Ref. ID ADHOC-D-26-02099
"Onset-Anchored Selective Computation for Resource-Constrained Vehicular Edge Networks"
(submitted as "Trustworthy Selective Computation for Resource-Constrained Vehicular Edge Networks"; retitled in this revision, see R3.7)

Response to Reviewers*

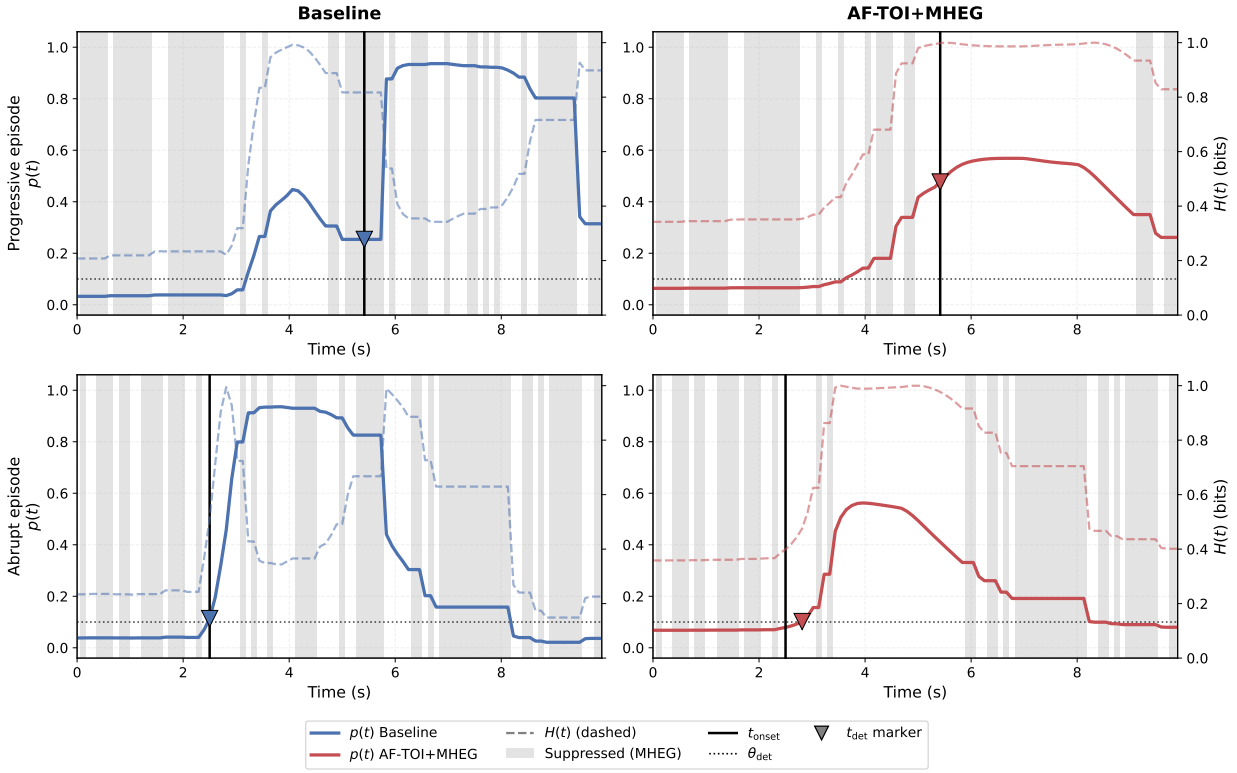
6. Comment: Frame-by-frame temporal evidence for seed 42 graph is not explained well.

Response: We agree with the reviewer. A frame-by-frame reading guide has been added to the paragraph following the first mention of Figure 5 in Section 4.2, identifying each visual element of the seed-42 examples. During revision verification we also found and corrected two problems in this figure, and we report them explicitly rather than silently: (a) the exemplar episodes of the submitted version were not selected by a stated criterion, and the abrupt exemplar was atypical (it belongs to a saturated minority of episodes whose entropy sits near the maximum throughout); the figure now uses, per regime, the episode with the *median* pre/post-onset entropy contrast among seed-42 critical episodes with central onset, and the caption states the criterion; (b) the replay that produced the suppression shading applied the entropy threshold in the wrong logarithm base (natural log instead of the base-2 entropy of Eq. 11), so the entropic branch of the gate never fired in that log; the log was regenerated with the correct base, and the entropy axes of Figures 4–6 are now uniformly

(The full frame-by-frame reading guide follows the first mention of Figure 5 in Section 4.2.) Its selection criterion reads: "The exemplars are selected by a pre-declared neutral criterion: within each regime, the episode whose pre/post-onset entropy contrast is the *median* among the critical episodes of seed 42 with a centrally located onset (progressive: episode 36, t_0=5.42 s; abrupt: episode 148, t_0=2.50 s)." The guide also states that detection markers of single exemplars do not arbitrate latency (aggregate latencies are settled by Table 8) and that a minority of abrupt critical episodes (12 of 48 in seed 42) runs near maximal entropy throughout. The regenerated figure is reproduced below.

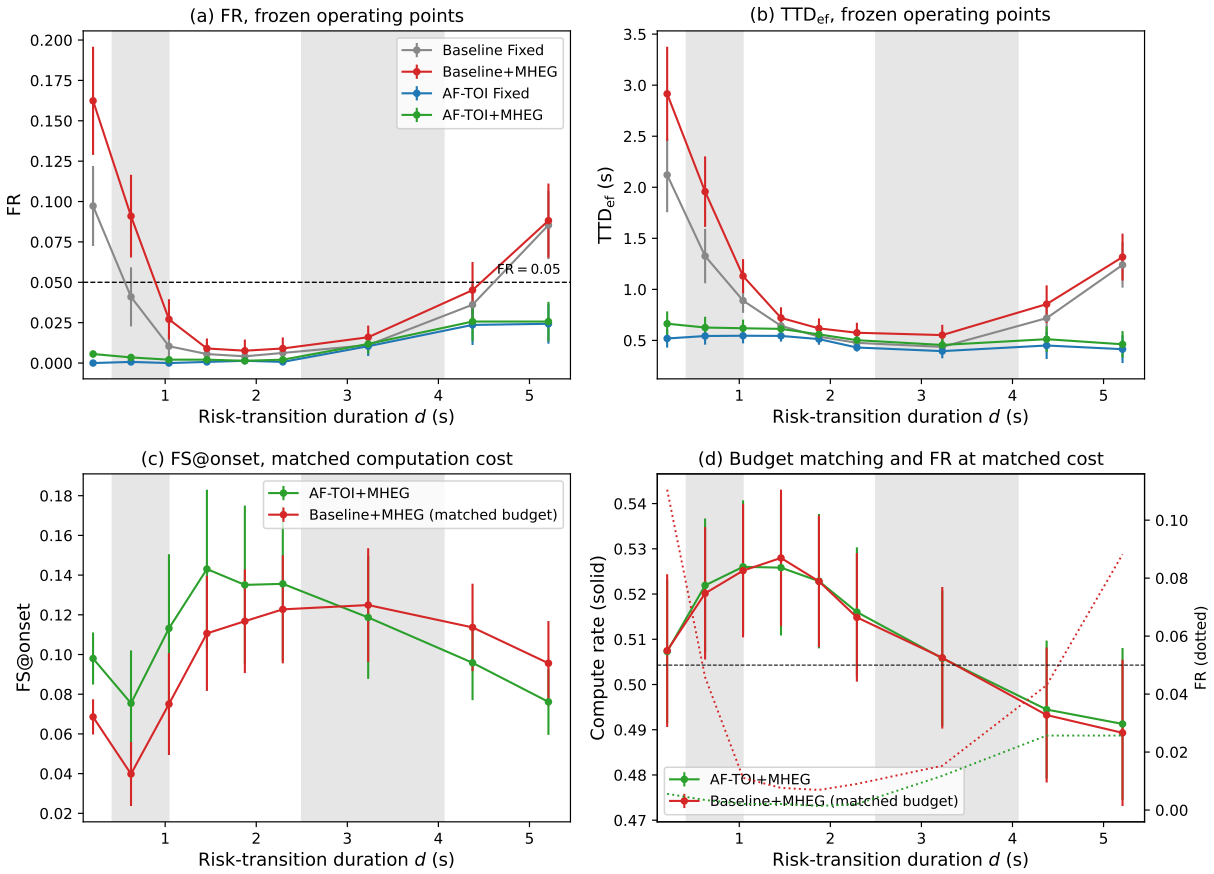
4. Comment: A central claim of the study is that temporal organization of uncertainty is important for safe selective computation, but the current experiments appear to be strongly tied to the risk-transition patterns defined by the experimental setup. The authors should investigate whether AF-TOI generalizes to unseen temporal risk trajectories, different onset durations, abrupt versus gradual transitions, intermediate-risk conditions, changes in the distribution of input features, or distribution shifts between training and testing conditions.

Response: We agree with the reviewer. To address the question of generalization across different transition durations, a new temporal-scale experiment has been added in Section 4.12, together with Figure 14 and Table 21. The experiment varies the risk-transition duration independently through a shape-preserving temporal warp while keeping t_0, the normalized transition shape, the episode context, the model weights, and the scheduler thresholds fixed. The limitations paragraph of Section 5 was also revised to distinguish this controlled temporal train–test shift from broader naturalistic distribution shift. The six aspects raised in the comment are addressed as follows.

"Figure 14a–b and Table 21 report the frozen operating points. AF-TOI maintains mean FR below 0.05 at every evaluated duration (maximum duration-wise mean 0.026), and $\mathrm{TTD}_{\mathrm{ef}}$ stays within approximately 0.40–0.66 s. The Baseline crosses mean FR = 0.05 at both extrapolation extremes (mean FR 0.097 at 0.21 s and 0.085 at 5.21 s for the fixed policy), and its $\mathrm{TTD}_{\mathrm{ef}}$ follows a U-shaped profile that reaches 2.12 s at the fast extreme. At the level of individual seed×duration cells, AF-TOI exceeds FR = 0.05 in 7 of 108 cells (all at $d \geq 3.23$ s, maximum 0.108), against 22 of 108 for the fixed Baseline (maximum 0.250) and 32 of 108 for Baseline+MHEG (maximum 0.333). Frame-level F1 remained seed-sensitive under the warp, a pattern consistent with checkpoint-level variability rather than with an effect of the warp itself. Accordingly, the result is restricted to aggregate coverage and effective delay and does not constitute a per-seed guarantee: AF-TOI shows aggregate temporal-scale robustness across the evaluated synthetic range of unseen risk-transition durations." (Section 4.12, second paragraph)

"Because the two frozen gates suppress different fractions of frames, we added a post-hoc matched-budget diagnostic: for each seed×duration cell, the entropy threshold of Baseline+MHEG was adjusted by bisection (...) until its computation rate (fraction of executed window updates; both arms share the recompute semantics of Section 3.4) matched that of AF-TOI+MHEG on the same cell (all 108 cells matched within 1.9%, tolerance 2%; Figure 14d). (...) At matched computation cost, no systematic FS@onset advantage remains (...). Under Holm correction within each endpoint family, only the $\mathrm{TTD}_{\mathrm{ef}}$ difference at 0.21 s remains significant ($p = 0.031$), so these per-duration matched-cost contrasts should be read as exploratory. The matched-budget diagnostic supports a temporal-scale coverage-and-timeliness advantage, not a universal improvement in near-onset suppression placement." (Section 4.12, third paragraph)
